Access Compliance Report

Public Rights-of-Way (Curb Ramps)

Intersection ID: 30336	Main Street: DULIN_CREEK_BV	Cross Street: FOUR SISTERS_LN	Location: SW
ADA ID: 6D154358AD7B	Ramp Type: BlendTrans1	Initial Pass/Fail: Fail	Overall Compliance: No
Severity Score: 10			
Codes/Mitigation Info/Possible Solution		Field Measurements/Component Compliance

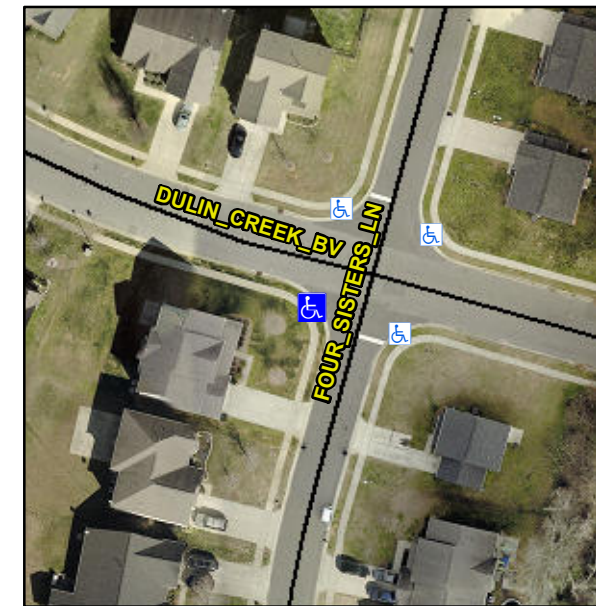
CURB WIDTH 46.0, CURB GAP 1.0

Not Found, R304.5.1, R304.5.3

Compliance	Description	Data	Compliance	Description	Data
N/A	Ramp Length (in)	47.5	Yes	BlendTrans Slope (%)	3.8
No	Ramp Width (in)	47.5	No	BlendTrans XSlope (%)	4.2
N/A	Flare Type LT	N/A	N/A	Flare Type RT	N/A
N/A	Flare Slope LT (%)	N/A	N/A	Flare Slope RT (%)	N/A
N/A	Flare Traversable LT?	N/A	N/A	Flare Traversable RT?	N/A
N/A	Landing Length (in)	N/A	N/A	DWS Provided?	N/A
N/A	Landing Width (in)	N/A	N/A	DWS Contrast?	N/A
N/A	Landing Slope (%)	N/A	N/A	DWS Length (in)	N/A
N/A	Landing X Slope (%)	N/A	N/A	DWS Full Width?	N/A
N/A	Landing Curb? (Y/N)	N/A	N/A	DWS Offset (in)	N/A
N/A	Shared Landing?	N/A			
N/A	Gutter Ponding?	N/A	N/A	Gutter Slope (%)	N/A
N/A	Gutter Lip Ht (in)	N/A	N/A	Gutter X Slope (%)	N/A
N/A	Painted X Walk1?	No	N/A	Painted X Walk2?	No
	X Walk 1 Direction	To E		X Walk 2 Direction	To N
	X Walk 1 Width (in)	N/A		X Walk 2 Width (in)	N/A
	X Walk 1 Slope (%)	2.1		X Walk 2 Slope (%)	3.3
	X Walk 1 X Slope (%)	1.4		X Walk 2 X Slope (%)	3.0

N/A	Ramp inside XWalk1?	N/A	N/A	Ramp inside XWalk2?	N/A
	Road Slope (%)	3.1		Clear Space?	N/A
	Road X Slope (%)	0.1	N/A	Clear Space to XWalk (in)	N/A
N/A	Any Obstructions?	N/A	N/A	Storm Grate/Utility Hazard?	N/A
	Obstruction Type			Storm Grate/Utility Type	
		N/A			N/A
			Yes	Surface Condition? (G/P)	Good
			No	Curb Slope (%)	13.4

Remove & Replace Curb Ramp With Two New Directional Ramps or Equivalent.
